**A Peer Review of the Strategy for  
Characterizing Transuranics and  
Technetium Contamination in Depleted  
Uranium Hexafluoride Tails Cylinders**

**September 1, 2000**

**G.P. Brumburgh, Project Lead**  
Lawrence Livermore National Laboratory

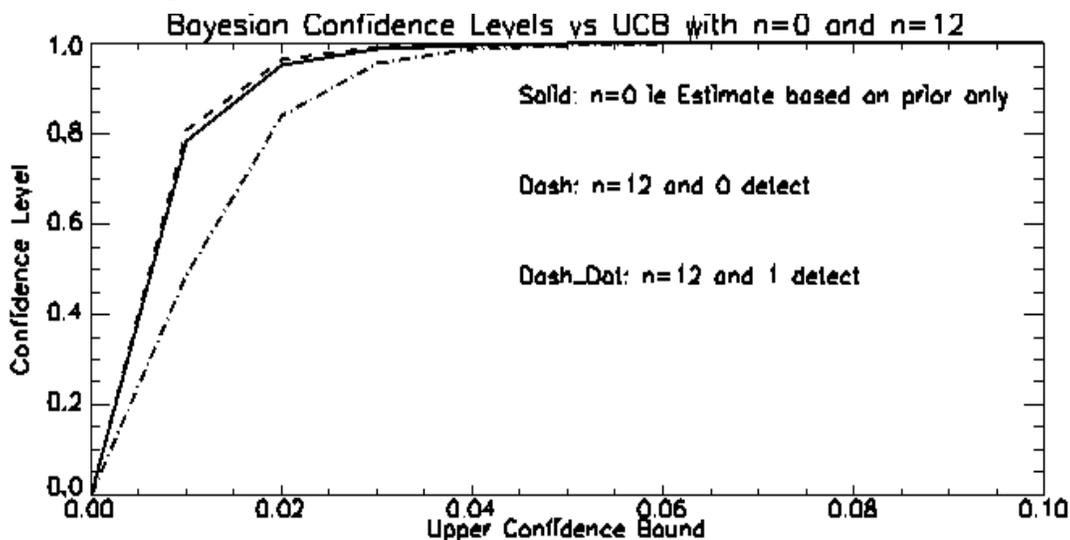
A significant amount of quantitative information is available based on prior analysis of cylinder data as evidenced in Table 1–3 and Table C1. Others have been alluded to in the proposal. Not using this information explicitly when possible restricts us to extremely conservative conclusion, leading to cruder confidence levels and larger sample requirements. These, in turn, lead to higher costs. The appropriate tool to use the prior information is provided in Bayesian statistics. Here, the prior information regarding the parameter to be estimated is captured in an appropriate prior distribution, and when new observations come in, they are used to update the prior distribution to one called the posterior distribution, from which confidence intervals for the parameters under investigation can be computed. As an example, suppose it is estimated that  $\pi = \text{Prob}$  (a contaminant concentration exceeds the detection level). Based on the data in Table C1, an appropriate prior for  $\pi$  may be chosen as beta (0.993, 151). Suppose now, in a sample of size 12, no cylinder is detected with a contaminant concentration exceeding the detection level. The updated distribution for  $\pi$  is a beta (0.993, 163). If instead, one cylinder in the sample had a contaminant concentration exceeding the detection level, then the corresponding posterior distribution for  $\pi$  will be beta (1.993, 162). The prior and the two posteriors are shown in the figure below.

Notice that the confidence parameters are significantly improved with the same sample size as recommended in the proposal. Some confidence parameter pairs that can be read approximately from the figure are (85, 1) and (99, 2) for no “detect” and (85, 2) and (99, 3) for one “detect.”
